ADDENDUM

NO. 3

PROJECT NAME: Hays High School 2025 Additions and Renovations

ADDENDUM DATE: 15 May, 2025

FIRST FLOOR PLAN - AREA
A - POWER

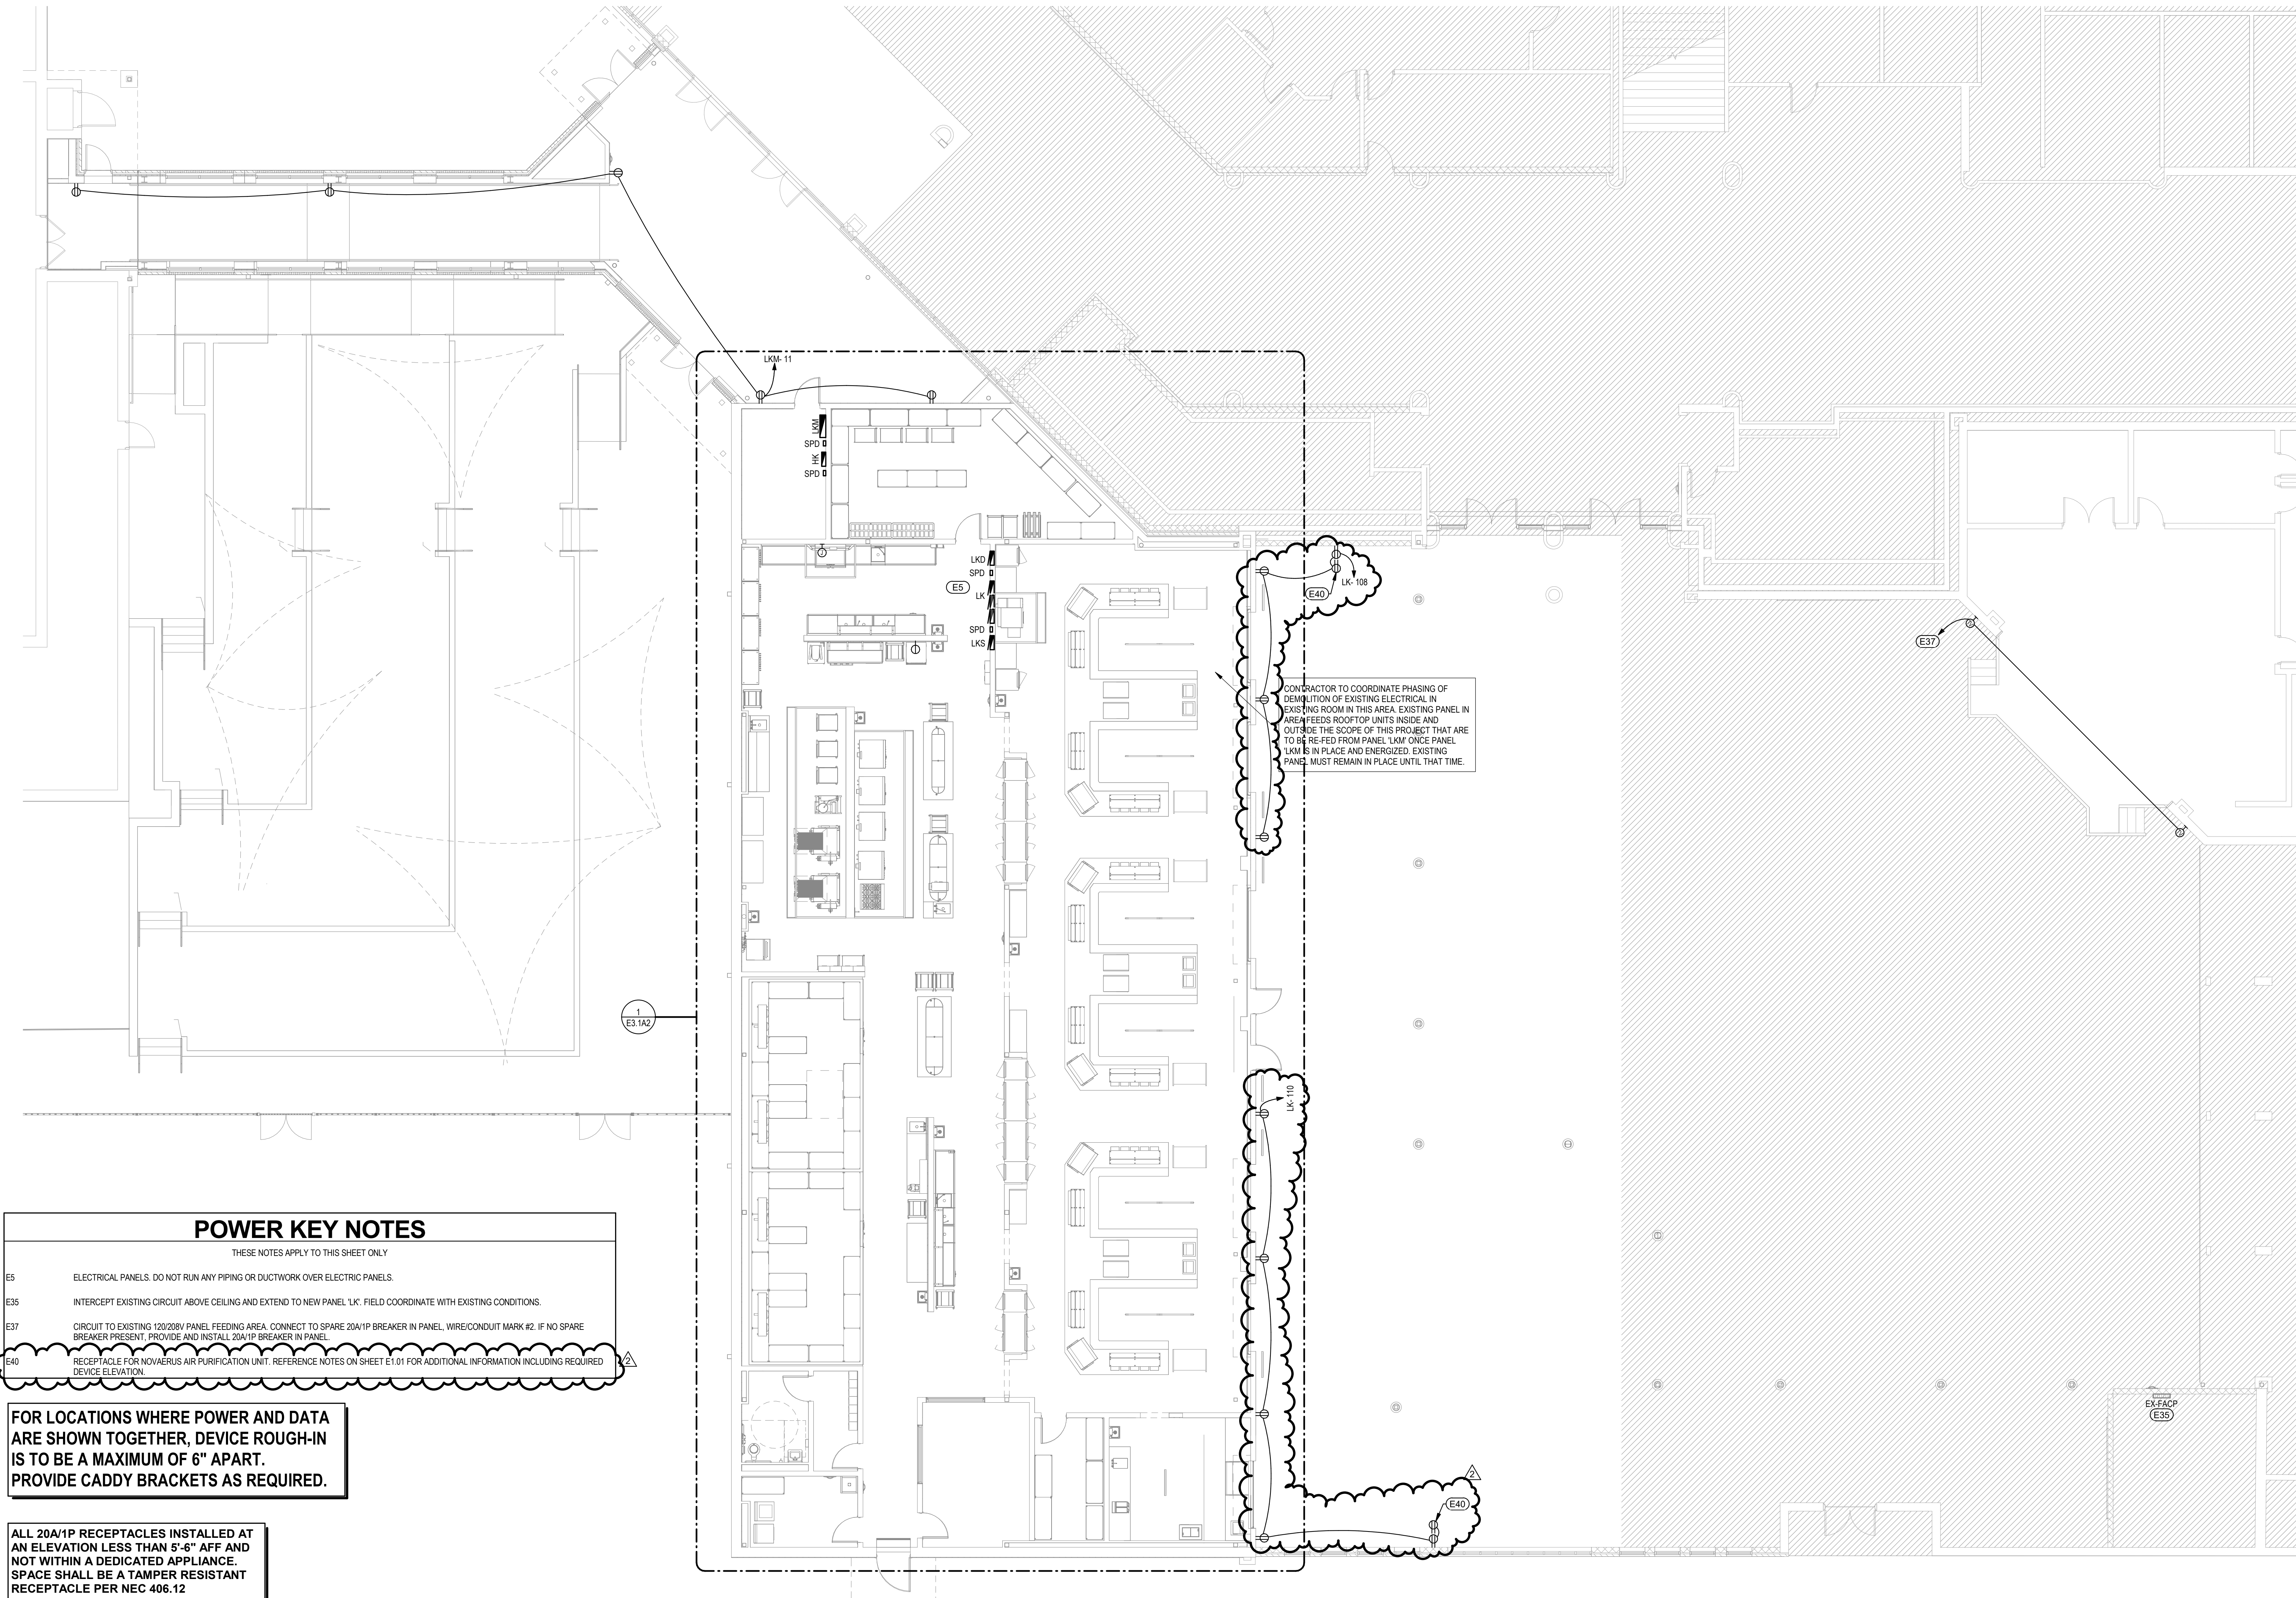
AD No 3, Elec Item 4: **To the Drawings, Sheet E3.1A1 "FIRST FLOOR PLAN - AREA A - POWER"**

- 1) Added receptacle and air purifier power as shown.
